SUBJECT: ADDENDUM No. 1

FILE: FHWTP Flocculation and Sedimentation Basins 1 & 8 Equipment Upgrade WT7093

**FLEMING HILL WATER TREATMENT PLANT FLOCCULATION AND
 SEDIMENTATION BASINS 1 & 8 EQUIPMENT UPGRADE PROJECT – WT7093**

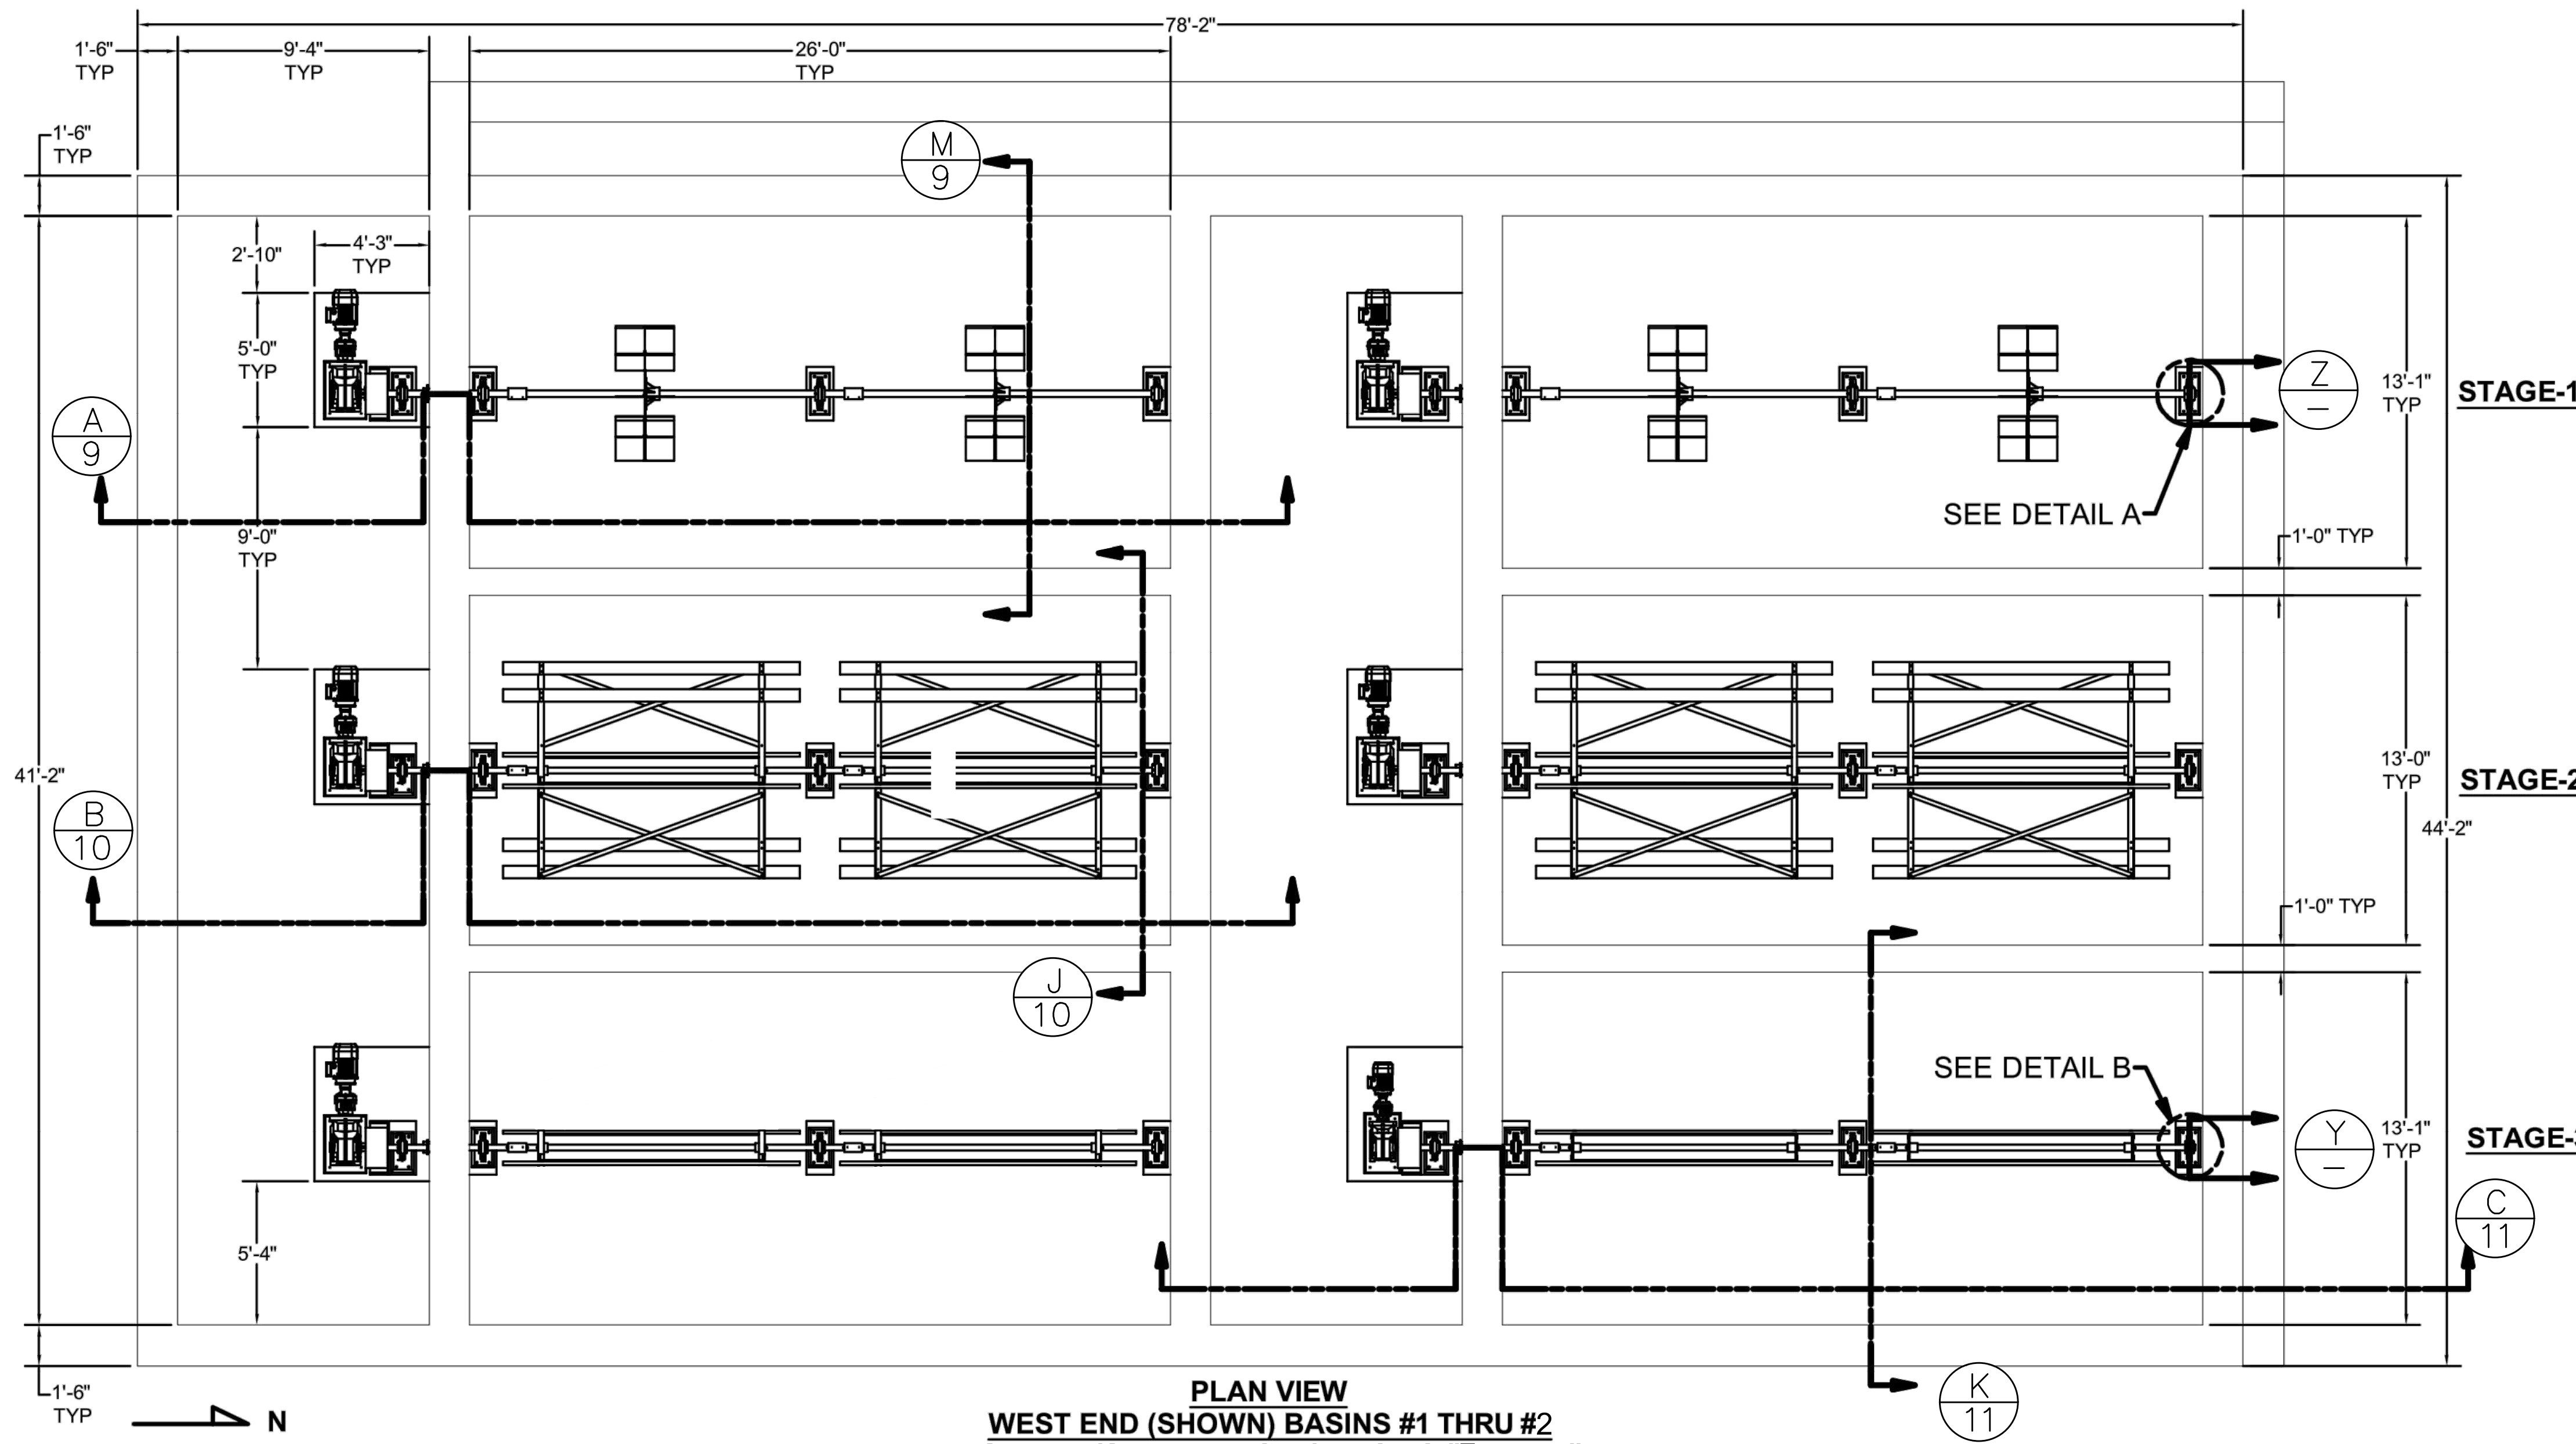
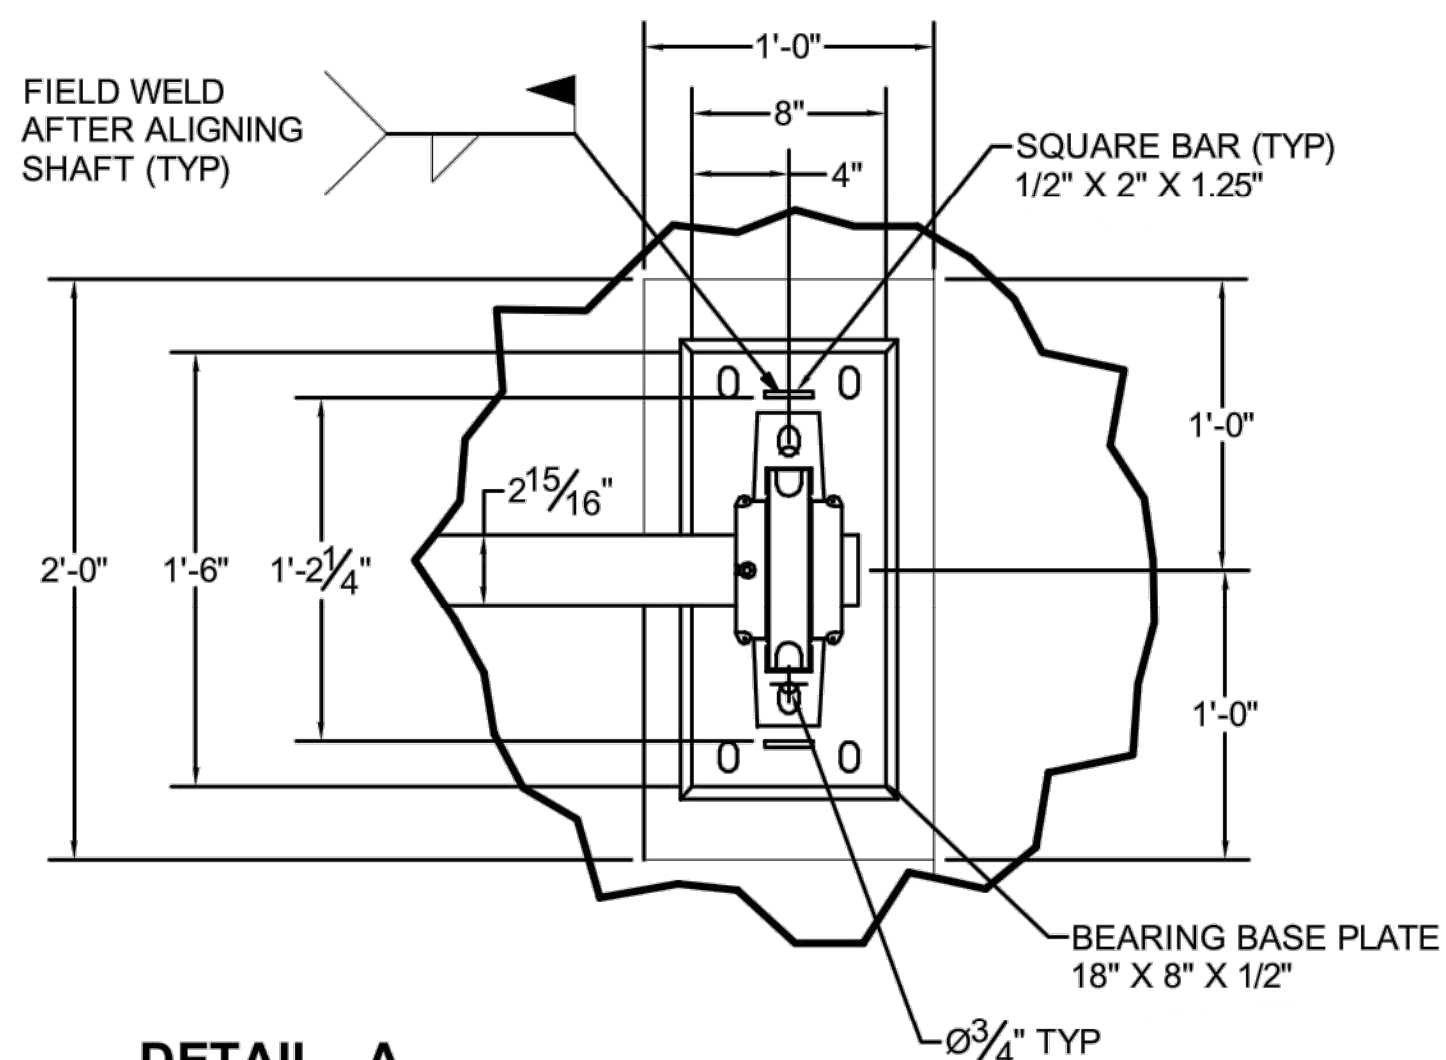
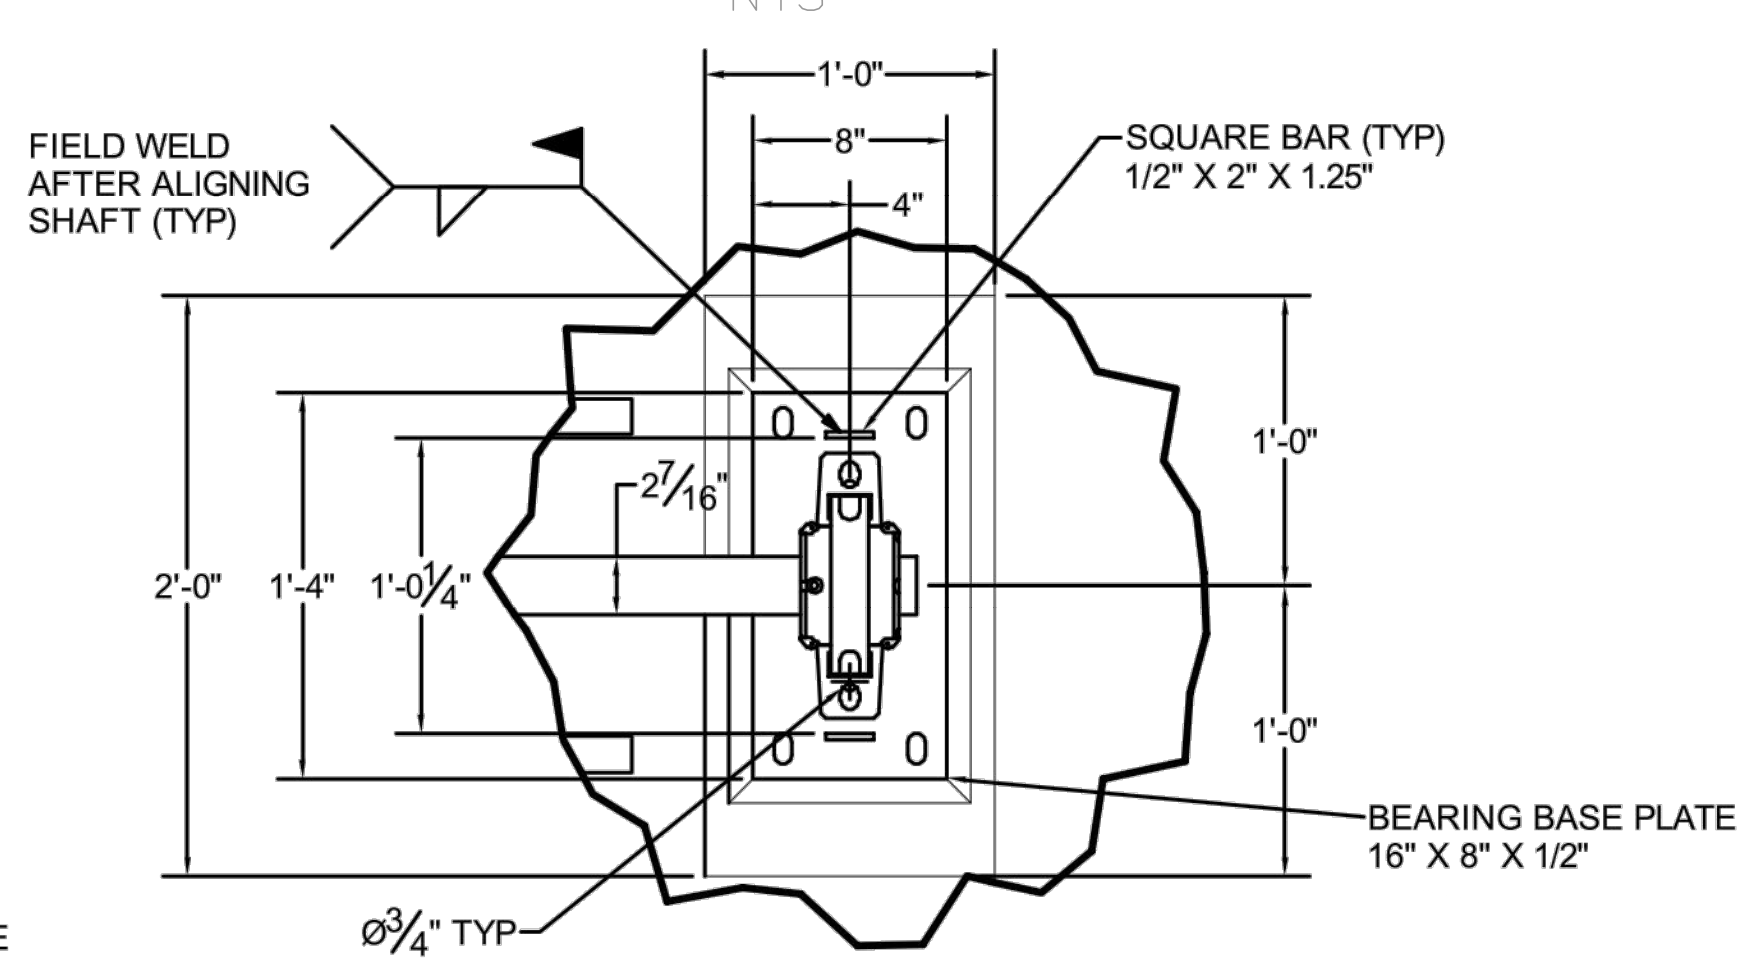
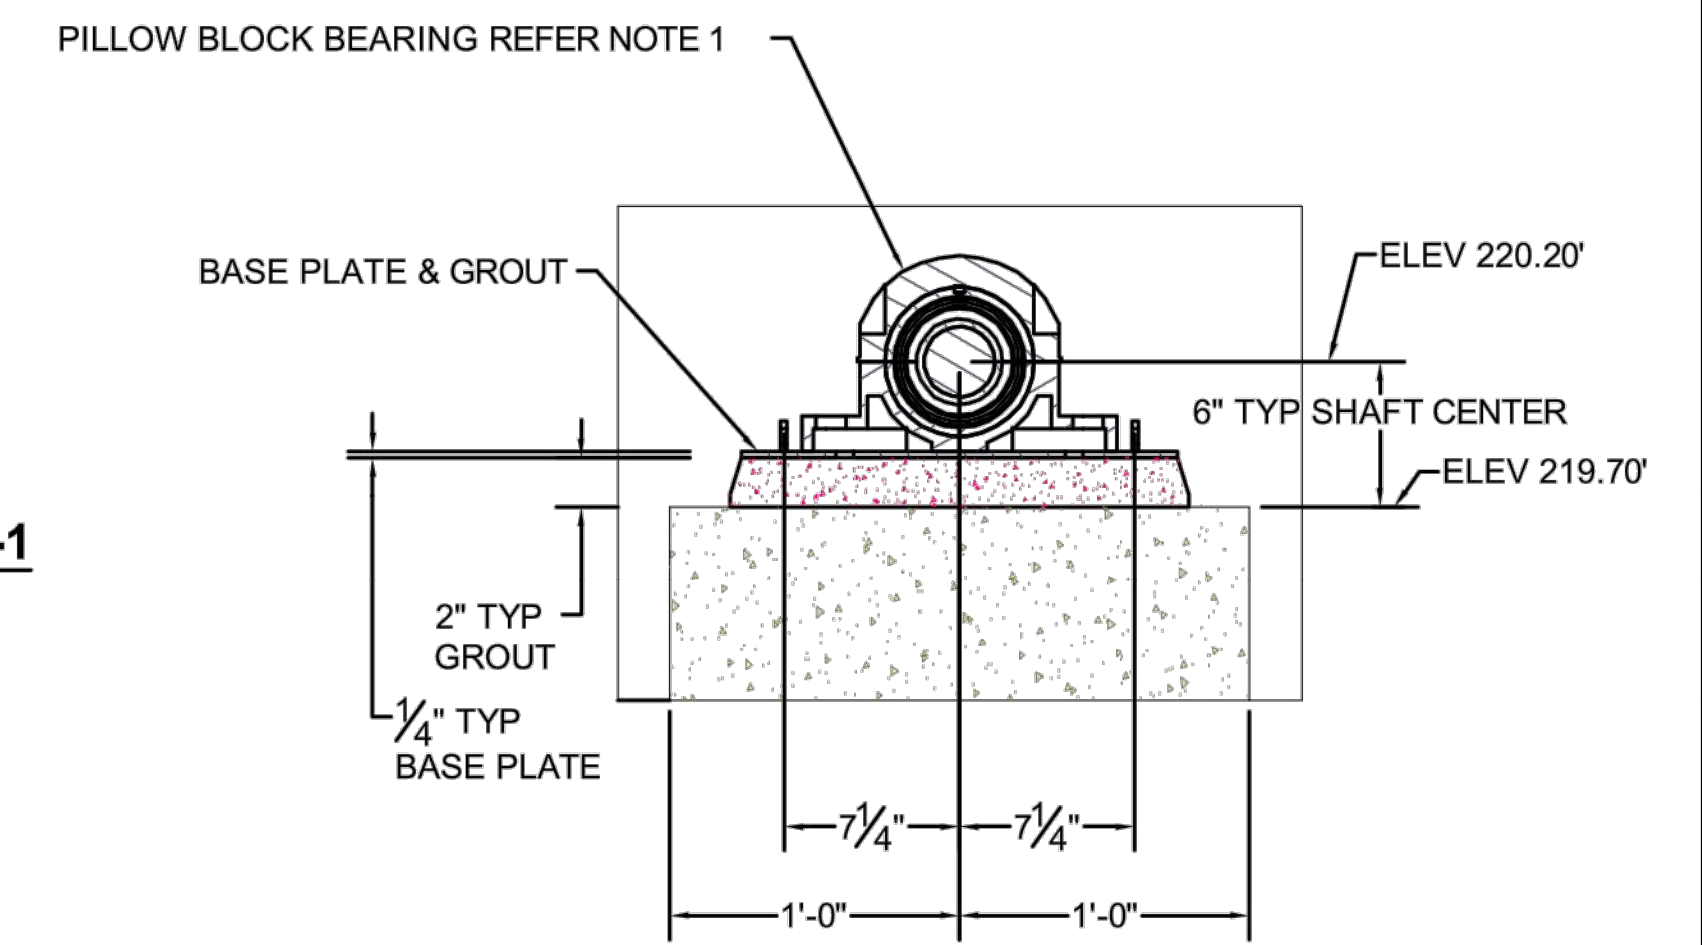
Sheet 7: Revised Notes. Moved Chain and Flight Details from Sheet 5.
